Model: R-C2 LCT (PS500)		Date: 8-Sep-09	No.: RB391001
Subject: Caster		Prepared by: S. Tomoe	
From: 2nd Tech Support Sec. Service Support Dept.			
Classification:	<input type="checkbox"/> Troubleshooting <input checked="" type="checkbox"/> Part information <input type="checkbox"/> Action required <input type="checkbox"/> Mechanical <input type="checkbox"/> Electrical <input type="checkbox"/> Service manual revision <input type="checkbox"/> Paper path <input type="checkbox"/> Transmit/receive <input type="checkbox"/> Retrofit information <input type="checkbox"/> Product Safety <input type="checkbox"/> Other () <input type="checkbox"/> Tier 2

Model: R-C2 LCT (PS500)		Date: 16-Sept-10	No.: RB391002
Subject: Part Number Correction		Prepared by: T. Nihei	
From: 1st Overseas Tech Support Sec., 1st PQM Dept.			
Classification:	<input type="checkbox"/> Troubleshooting <input type="checkbox"/> Mechanical <input type="checkbox"/> Paper path <input type="checkbox"/> Product Safety	<input checked="" type="checkbox"/> Part information <input type="checkbox"/> Electrical <input type="checkbox"/> Transmit/receive <input type="checkbox"/> Other ()	<input type="checkbox"/> Action required <input t

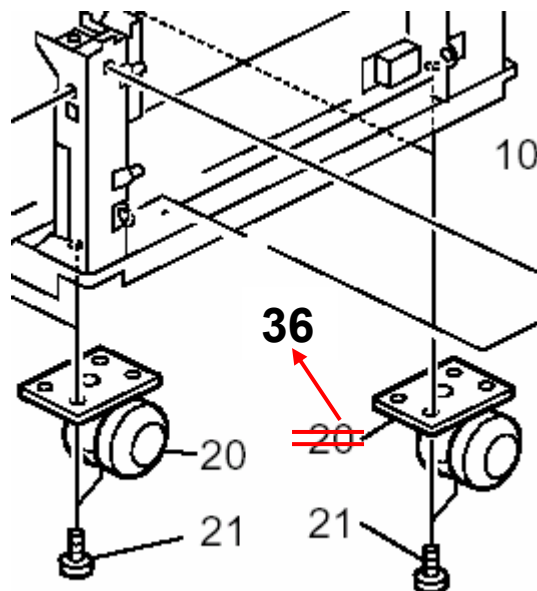
Old part number	New part number	Description	Q'ty	Int	Page	Index	Note
A5071096		Pan Head Screw M5x5	16-8		3	21	A
AH012036	D3511120	Caster: Dia50H59: Stopper: Yes	4-2	O/O	3	20	A, B
	D3511121	Caster: Dia50H59: Stopper: No	0-2		3	36	A

Change/Reason: Parts Catalog Correction

Change/Reason: Parts standardization.
